PERMIT # 191929 *Valk, Birch + Co* CITY OF Portland BUILDING PERMIT APPLICATION MAP # \_\_\_\_\_ LOT# 1

RE: Lot #13 Hillcrest

Your application to construct a single family dwelling has been reviewed and a permit is herewith issued subject to the following requirements:

**CITY OF PORTLAND, MAINE**  
**SITE PLAN REVIEW**  
 Processing Form

LOT #13

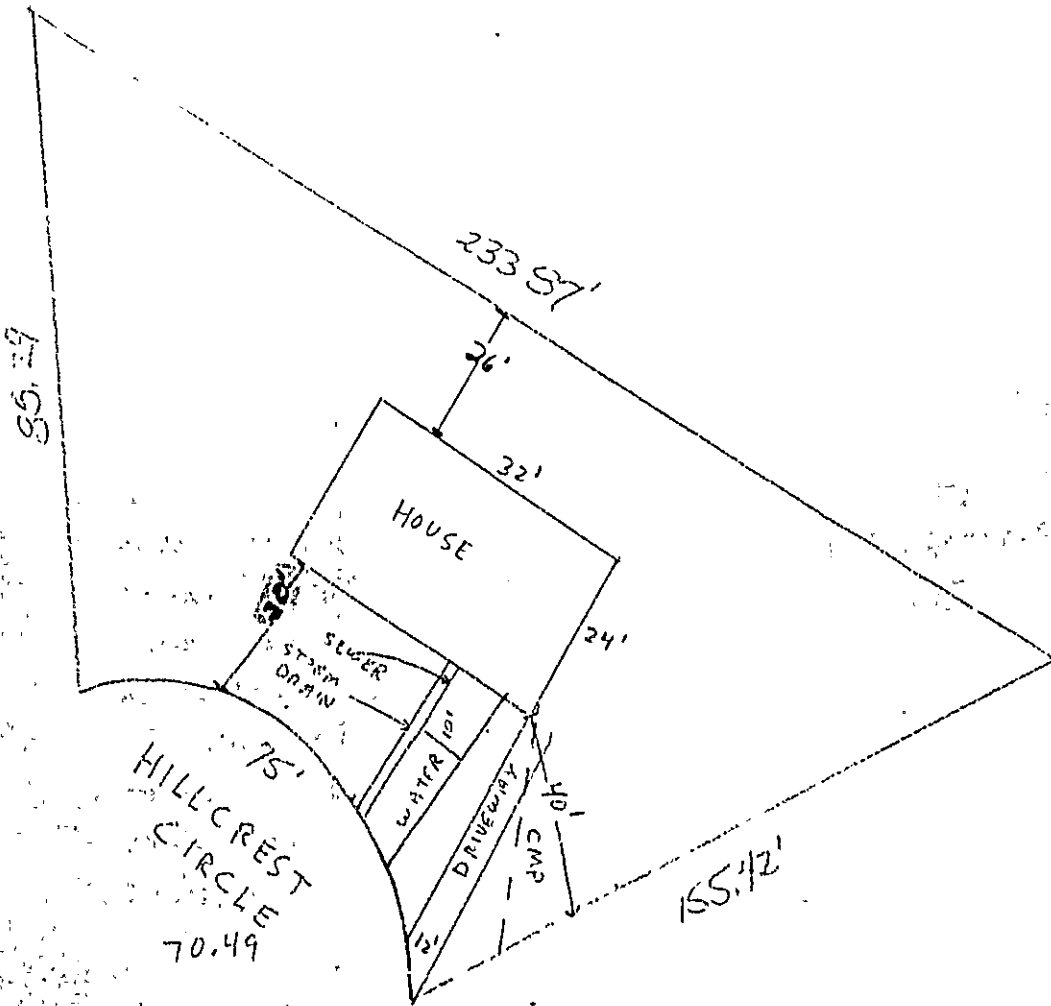
needs raised steps
